# UNITED STATES PATENT AND TRADEMARK OFFICE

APPLICATION NO.	FILING DATE	FIRST NAMED INVENTOR	ATTORNEY DOCKET NO.	CONFIRMATION NO.
10/582,432	03/27/2007	Wilfried Maier	1401D-001 (C10139US)	4877
25215	7590	05/20/2009	EXAMINER	
DOBRUSIN & THENNISCH PC			CLARK, MAYA ANGELICA	
29 W LAWRENCE ST			ART UNIT	PAPER NUMBER
SUITE 210				3742
PONTIAC, MI 48342			MAIL DATE	DELIVERY MODE
			05/20/2009	PAPER

<b>Office Action Summary</b>	<b>Application No.</b> 10/582,432	<b>Applicant(s)</b> MAIER, WILFRIED
	<b>Examiner</b> MAYA CLARK	<b>Art Unit</b> 3742

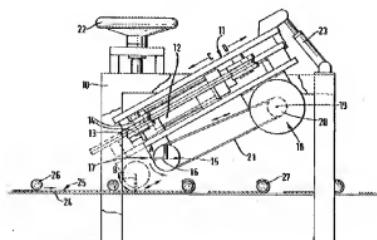
Barnes discloses a food rolling device consisting of a conveyor system (5) arranged beneath another conveyor system (6). Both bending means i.e. conveyor systems work together to bend and roll the food product slices (see figure below and col.3, lines 24-32). The Barnes device is effective in carefully rolling food products such as cheeses in order to prevent breakage during the bending and subsequent rolling processes (col.1, lines11-21).
